<b>DART AEROSPACE LTD</b>		<b>Work Order:</b> 120871
<b>Description:</b> Crosstube Assembly		<b>Part Number:</b> D407-667-145
<b>Inspection Dwg:</b> D407-667-145 Rev: C		<b>Page 1 of 2</b>

DESIGN	9	<b>DART AEROSPACE LTD</b>	
DRAWN	RF	HAWKESBURY, ONTARIO, CANADA	
CHECKED	4	DRAWING NO.	REV. C
MFG. APPR.	4	D407-667-145	SHEET 2 OF 4
APPROVED	4	TITLE	SCALE
DE APPR.	4	CROSSTUBE ASSY (407 HIGH FWD)	NTS
DATE	08.11.06	COPYRIGHT © 2002 BY DART AEROSPACE LTD <small>THIS DOCUMENT IS PRIVATE AND CONFIDENTIAL AND IS SUPPLIED ON THE EXPRESS CONDITION THAT IT IS NOT TO BE USED FOR ANY PURPOSE OR COPIED OR COMMUNICATED TO ANY OTHER PERSON WITHOUT WRITTEN PERMISSION FROM DART AEROSPACE LTD.</small>

DRAWING NO. D407-667-145	TITLE CROSSTUBE ASS'Y (407 HIGH FWD)	REV. C	<b>DART AEROSPACE LTD ENGINEERING ORDER</b>		D.E.O. NO. D407-667-145-C-1	SHEET NO. SHEET 1 OF 1	SCALE NTS
DRAWN <i>q</i>	CHECKED <i>ASS</i>	MFG. APPR. <i>KB</i>	APPROVED <i>WD</i>		DE APPR. <i>##</i>		
DATE 11.07.15	DATE 11.07.22	DATE 11.07.22	DATE 11/07/22		DATE 11.07.21

DRAWING NO. D407-667-145	TITLE CROSSTUBE ASS'Y (407 HIGH FWD)	REV. C	DART AEROSPACE LTD ENGINEERING ORDER		D.E.O. NO. D407-667-145-C-2	SHEET NO. SHEET 1 OF 1	SCALE N

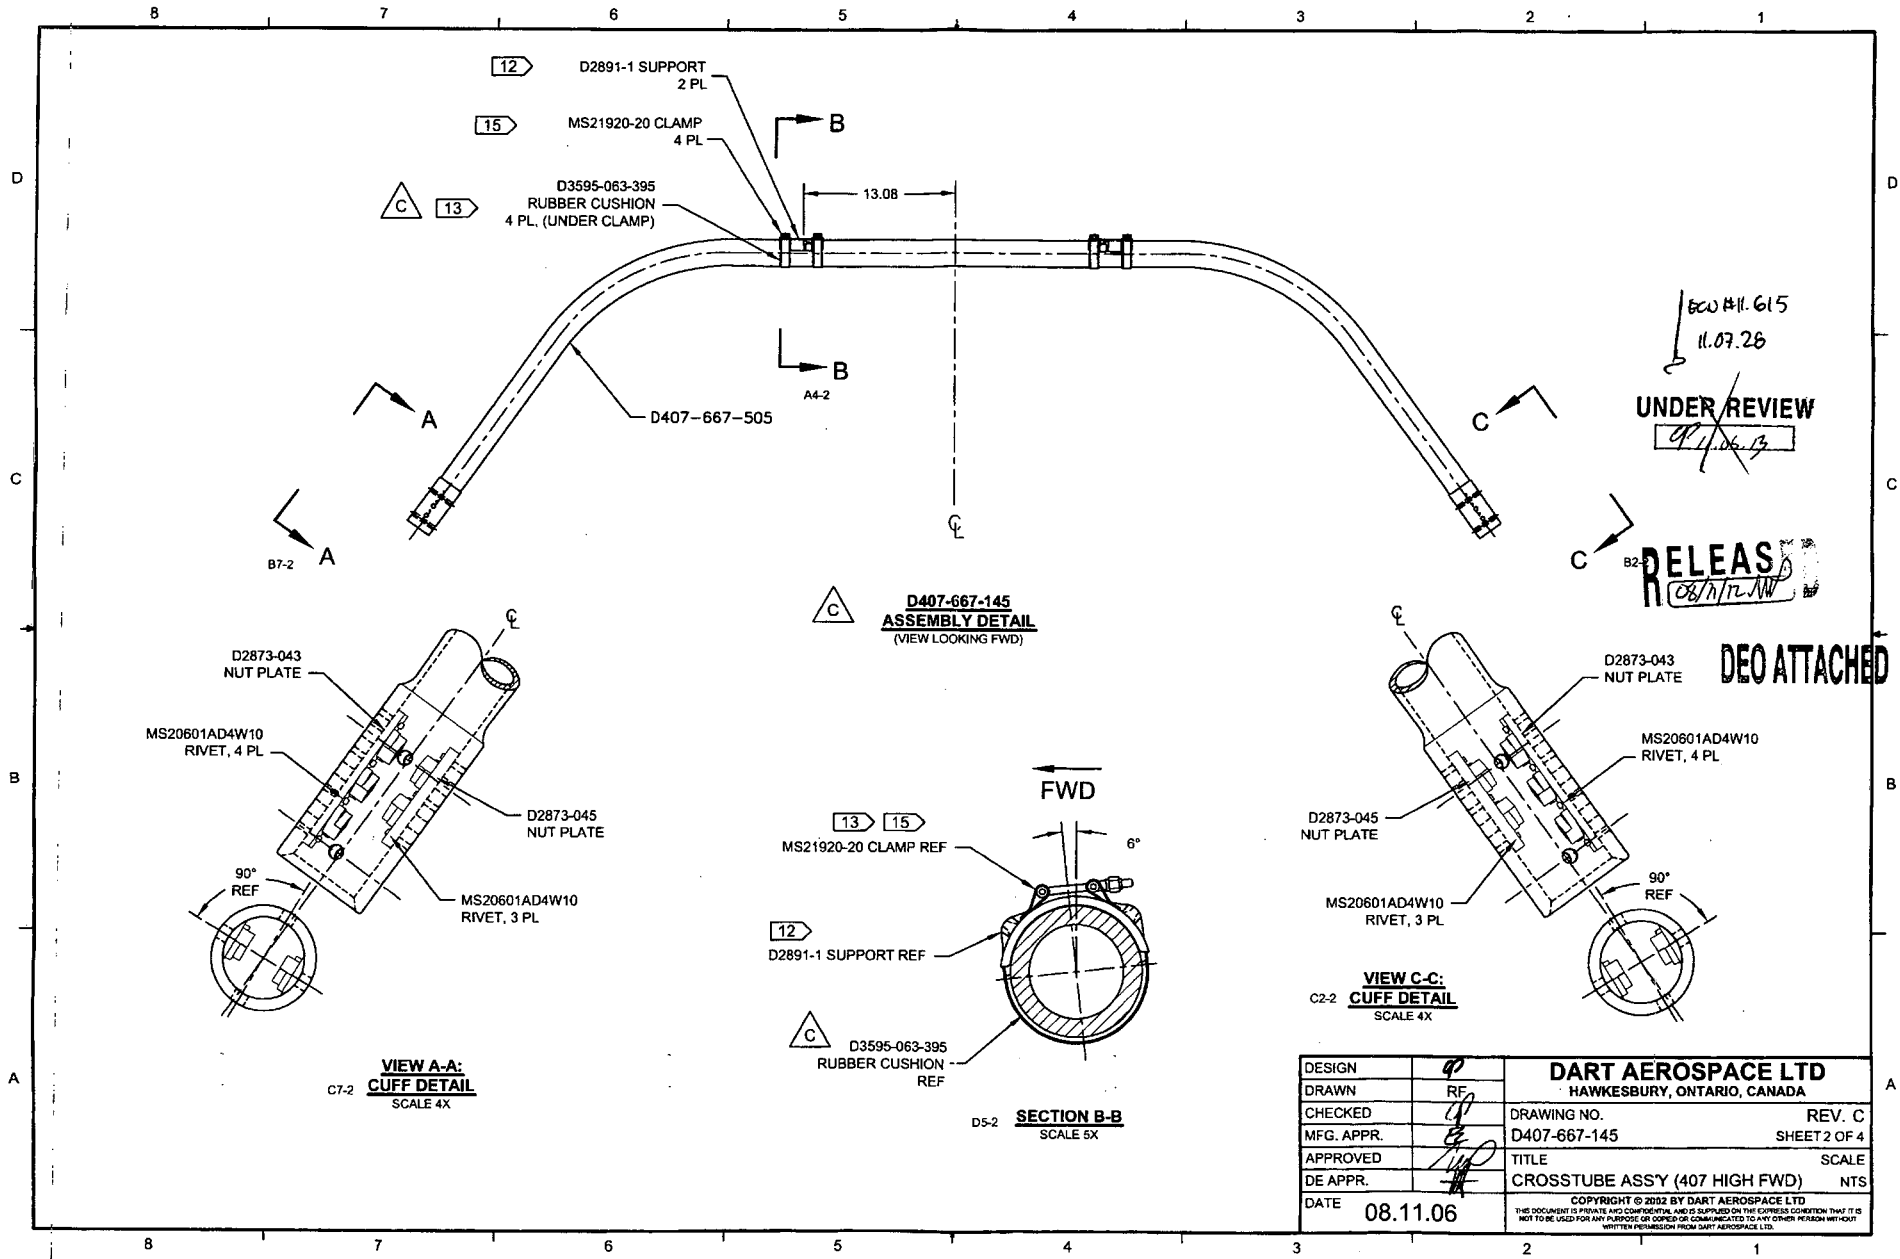
C	REVISE GENERAL NOTES/PART LIST (ZN D7-1); REORGANIZED VIEWS AND REFORMATTED DRAWING TO CURRENT STANDARDS. D3595-063-395 WAS D2858-400-694 (ZN D6-2 & A5-2); REMOVED REF. 7 ADD TOLERANCES (ZN C6-3, C4-3, D2-3); RELOCATED FLAG #6 (ZN A8-3) PER NCR 210; MOVED TURNING DETAIL & UPDATED TOLERANCE TO SHEET 4.	RF	08.11.06
B	ADD HOLES AND NUT PLATES FOR COMPATABILITY WITH BHT/AA SKUDTUBES	PH	05.07.26
A	NEW ISSUE	CP	02.05.08
REV.	DESCRIPTION	BY	DATE
DESIGN	RF	DART AEROSPACE LTD HAWKESBURY, ONTARIO, CANADA	
DRAWN	RF	DRAWING NO.	REV. C
CHECKED	RF	D407-667-145	SHEET 1 OF 4
MFG. APPR.	RF	TITLE	SCALE
APPROVED	RF	CROSSTUBE ASS'Y (407 HIGH FWD)	NTS
DE APPR.	RF	COPYRIGHT © 2002 BY DART AEROSPACE LTD THIS DOCUMENT IS PRIVATE AND CONFIDENTIAL AND IS SUPPLIED BY THE EXPRESS CONDITION THAT IT IS NOT TO BE USED FOR ANY PURPOSE OR COPIED OR COMMUNICATED TO ANY OTHER PERSON WITHOUT WRITTEN PERMISSION FROM DART AEROSPACE LTD.

**DETAIL P**  
BONDING STRAP INSTALLATION 2 PL

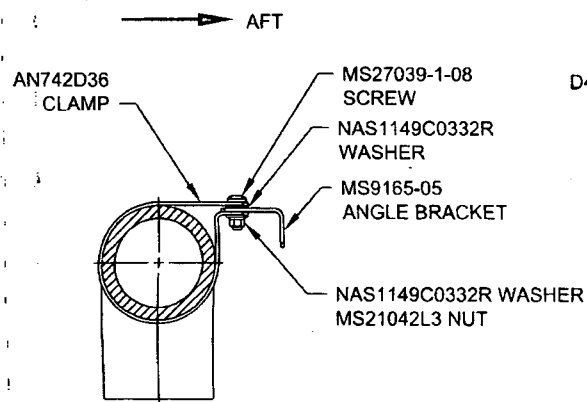
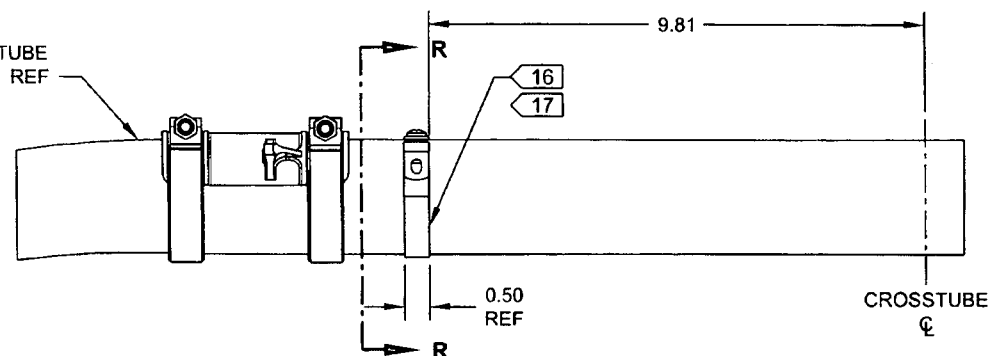
ADD ELECTRICAL GROUNDING STRAP

ITEM	QTY	PART NUMBER	DESCRIPTION
1	X	D407-667-145	CROSSTUBE ASSEMBLY (407 HIGH FWD)
10	2	AN742D36	CLAMP
11	2	MS9165-05	ANGLE BRACKET
12	2	MS21042L3	NUT (OR MS21042-3)
13	2	MS27039-1-08	SCREW
14	4	NAS1149C0332R	WASHER (OR AN960C10L)

- 16) MASK AREA UNDER CLAMP PRIOR TO PAINTING
- 17) SEAL EDGES WHERE AN742D36 CLAMP MEETS WITH THE CROSSTUBE USING SIKAFLEX-241/-291 OR MIL-S-8802 CLASS B2 OR PROSEAL 890 SEALANT
- 18) PERFORM RESISTANCE CHECK TO ENSURE MAX RESISTANCE IS 10 MILLIOHMS
